TECHNICAL BULLETIN

<p>Subject</p> <p>CHANGE TO COOLANT SPECIFICATION PRECAUTIONS</p>	<p>Model XK8 Year LATE 1999 MY VIN 042635 ONWARDS Model V8 XJ SERIES Year LATE 1999 MY VIN 878274 ONWARDS</p>
--	--

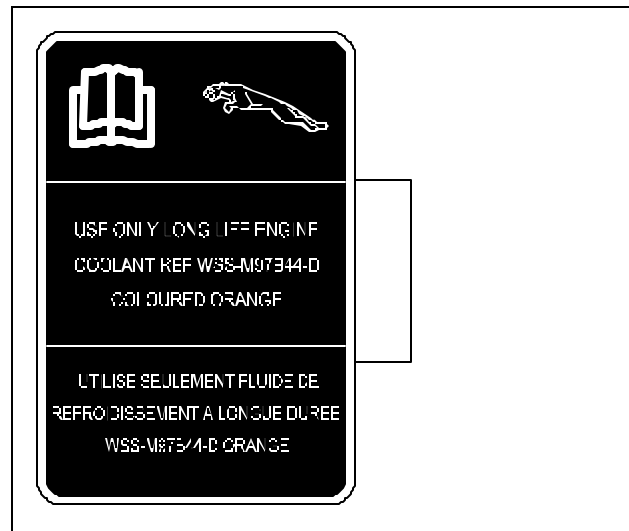
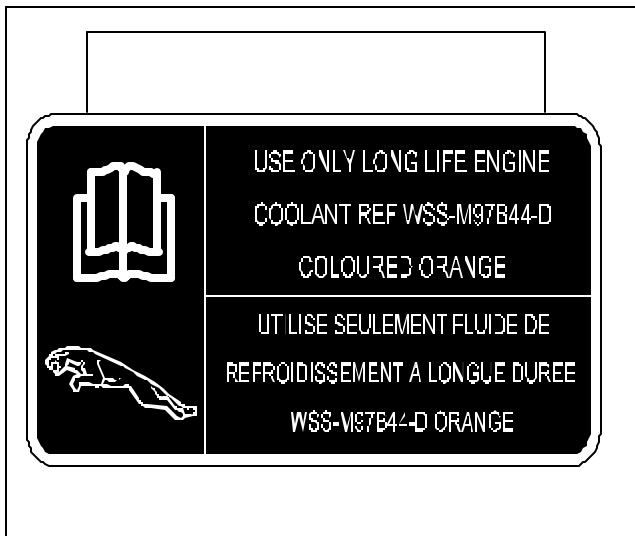
The specification of coolant filled during production has changed at the VINs listed above.

The new coolant is known as Extended Life Coolant (XLC) or Long Life Engine Coolant and may be recognized by its distinctive **orange** color. 2000 Model Year vehicles also utilize the same coolant, from VIN 00083 (XK8) and from VIN F00108 (V8 XJ Series).

- (i) Extended Life Coolant is colored **orange**
- (ii) Vehicles filled with Extended Life Coolant may also be recognized by labels applied to the header tank, similar to those illustrated above.

Header tank labels may differ in detail from the above illustrations, depending on model variants and Markets.

It is important that vehicles filled with Extended Life Coolant are **never** topped up with earlier-type coolants such as D542 or D985.

The various coolant products should **always** be kept separate and never mixed.
